At the request of AFS-420 in Oklahoma City, the PARC PBN Criteria Working Group reviewed and discussed in detail a proposal for modification of the RNP AR approach criteria, Order 8260.52, in the area of the visual segment analysis. They had prepared a white paper proposing to remove the requirement for extending the visual segment obstacle identification surface (OIS) 5 seconds past the DA(H) when the OIS expansion does not reach the width of 1xRNP at the DA. The WG was asked to review and support or amend the proposal.

White Paper on RNP AR Visual OIS and buffer

PURPOSE: The purpose of this paper is to discuss whether the RNP AR visual OIS/buffer area is a redundant requirement resulting in unnecessary effort without any added benefit.

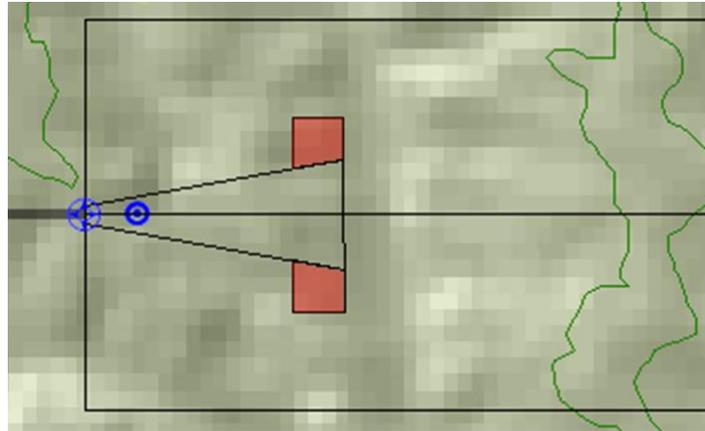
DISCUSSION: The visual OIS buffer area (highlighted in red) is equal to the height of the VEB OCS. The rest of the visual OIS is equal to 1 degree below the GPA therefore higher than the buffer surface.

PROPOSAL: Revise the RNP AR visual OIS area to be consistent with non-AR criteria and delete buffer area altogether.

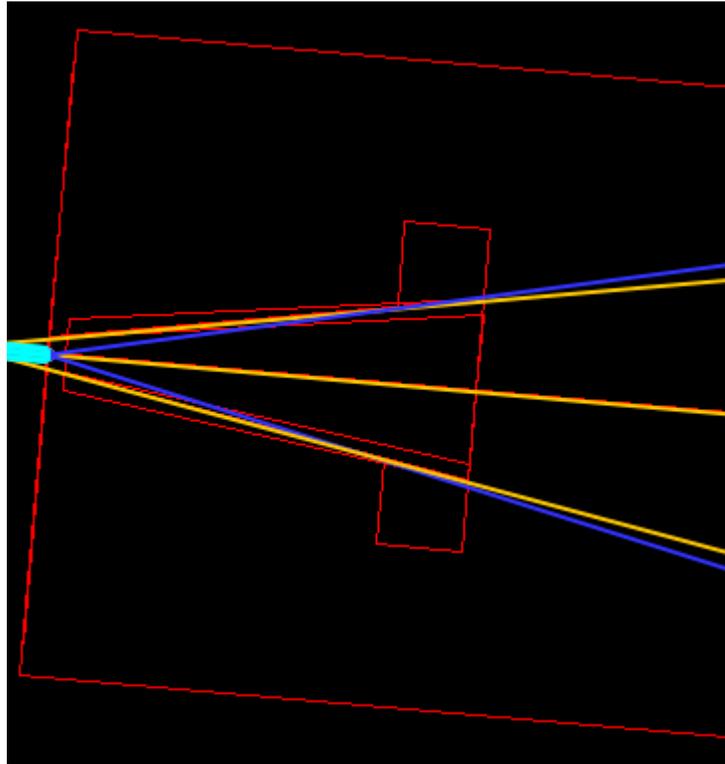
Compare below the visual OIS/buffer (red) to the typical PAPI (yellow) and MALSF lateral coverage areas (blue). It doesn't seem practical that a pilot with an undetected cross-track error at DA would be able to acquire the visual references and continue to the runway from any point in the buffer.
